ADDENDUM NO. 1
for
18-0032-EN MSB Garage Restoration
Clearwater, Florida

SUBJECT: Addendum No. 1

Job: CLEARWATER MUNICIPAL
PARKING GARAGE

SK-01

SUPPLEMENTAL BEARING SUPPORT

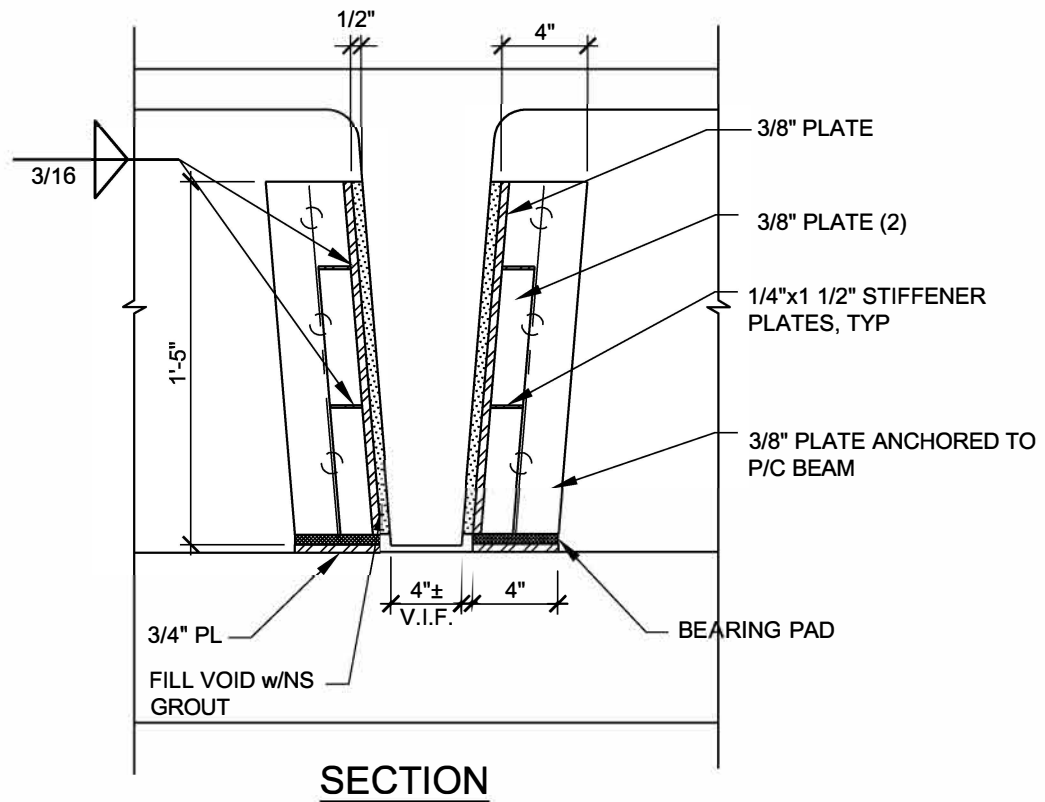
1. **Question:** On Work Item 40.4 Supplemental Bearing Support Bracket can we get more clarification on the following:
 - a. Thickness of the plate that anchors go thru
 - b. Thickness of back plate the stiffeners weld to
 - c. Width of the bracket assembly
 - d. Is there way to get a front or back view of the detail
2. **Answer:** See attached diagram which has been added to address the questions listed above

NOTE: REFER TO W.I. 40.4 FOR ADD'L INFORMATION, INCLUDING DIMENSIONS.
